Updated Networks – Aug 17, 2020

The ‘WF TDM v8.3.1 - 2020-05-08’ model version included most but not all of the highway and transit network changes that were part of MAG’s RTP amendment. Because the networks reflect the “official” MAG amended plan, the travel model was reissued with a new date stamp. However, since there were no changes to the model itself or the other modeling inputs, the version number of the travel model remained the same.

Figure 1: Added lanes between v8.3.1 2020-05-08 and v8.3.1 2020-08-17

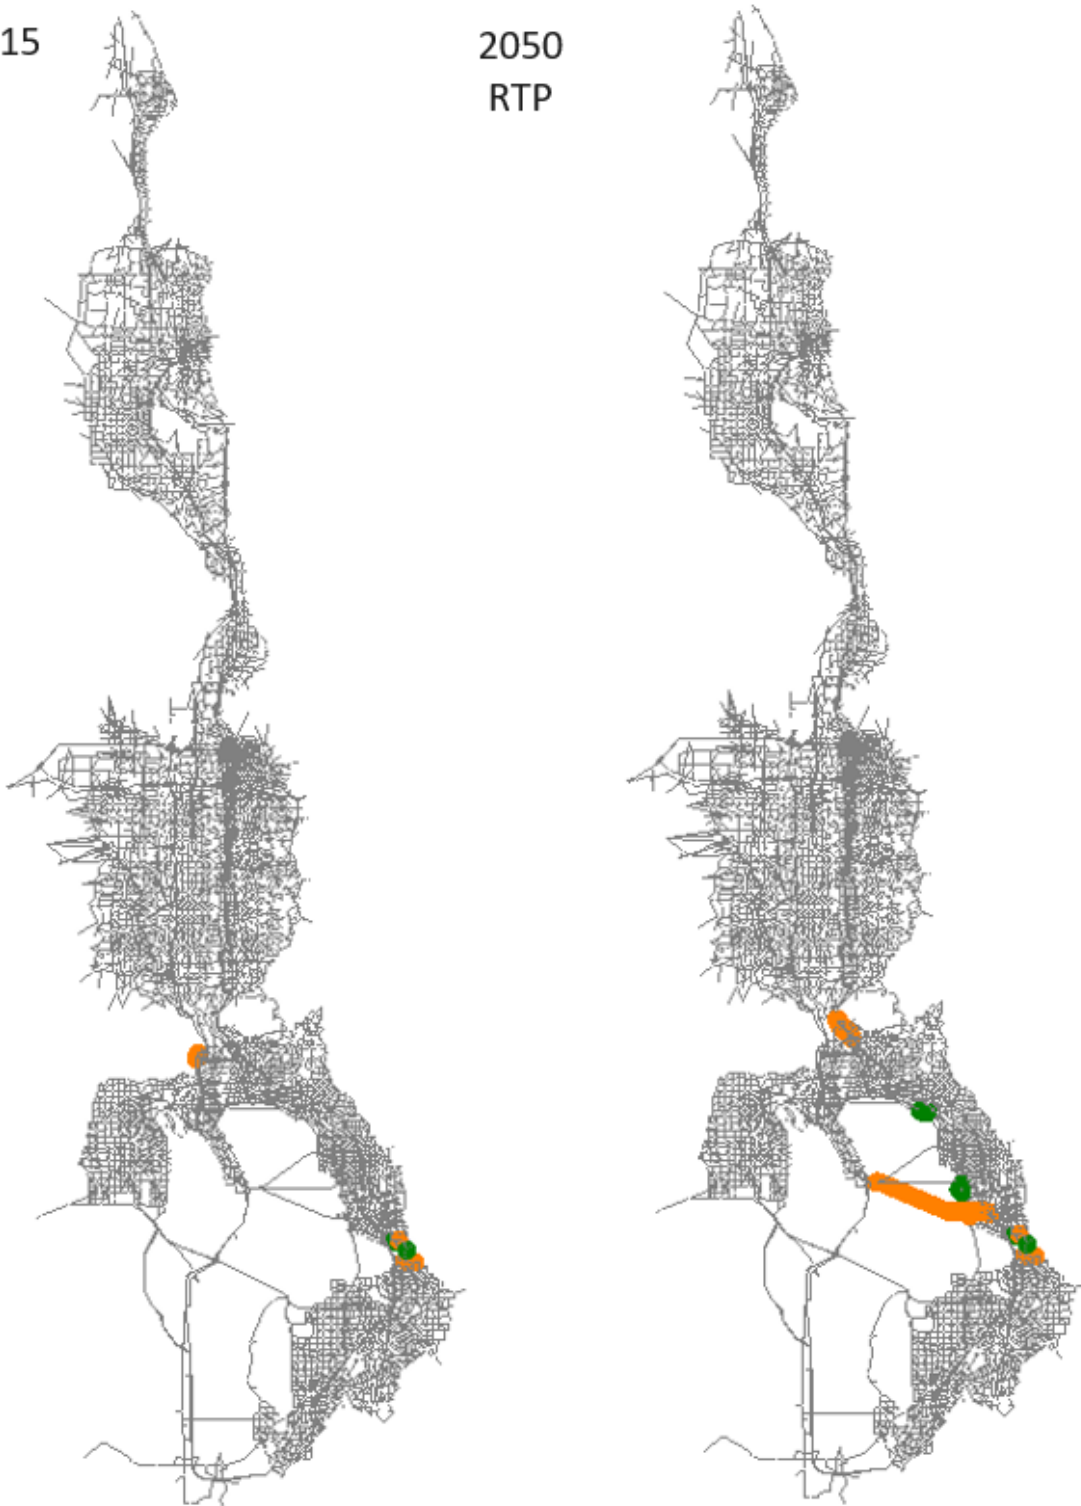
Figure 1 shows where lanes were added (green) or were taken away (orange) between ‘WF TDM v8.3.1 - 2020-05-08’ and ‘WF TDM v8.3.1 - 2020-08-17’ highway networks. Express bus routes were also removed from the MAG line files in the 2030, 2040 & 2050 Funded & Needed Transit folders .
